# FLOOR PLAN

Moos Farm LLC.

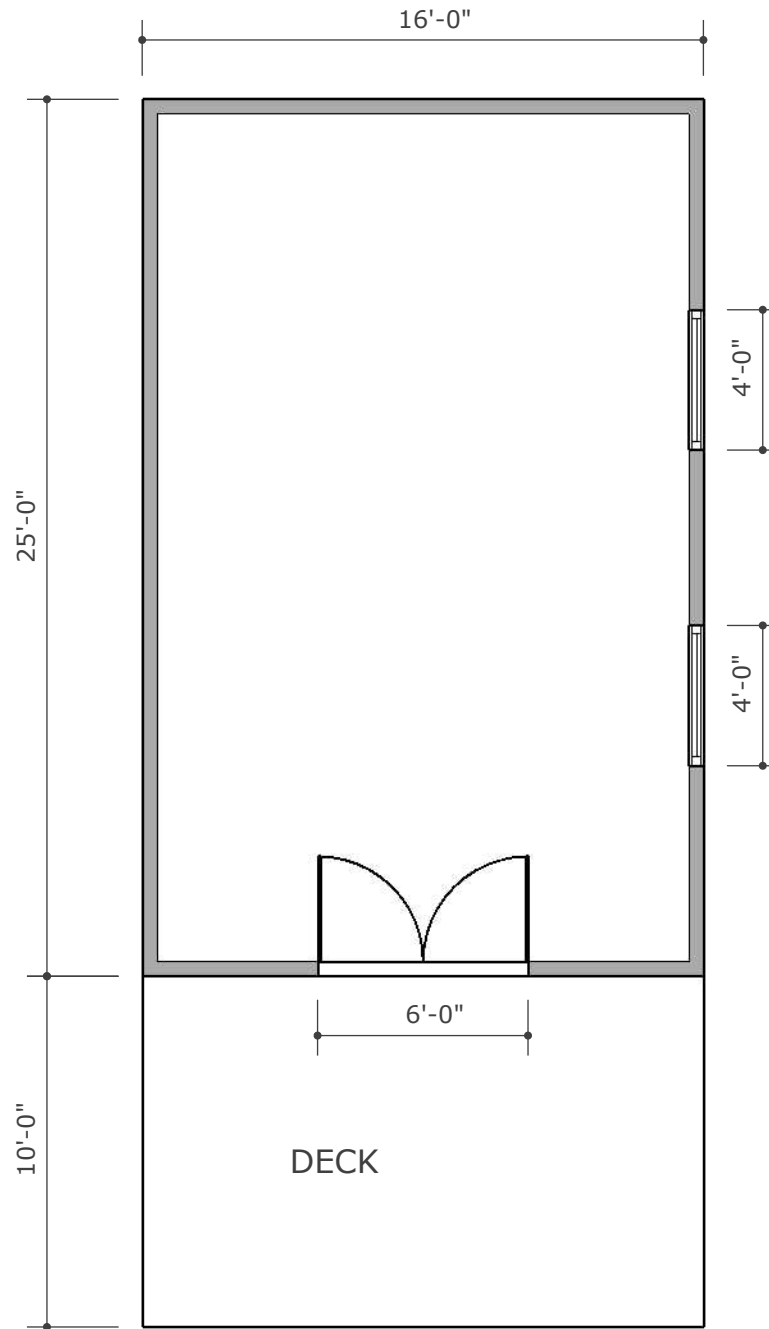
Ceiling joists  
required. Frame  
same as building

Revised 12/15/2022. Owner to use 2-2x12 ridge beam and support  
beam for porch ceiling.
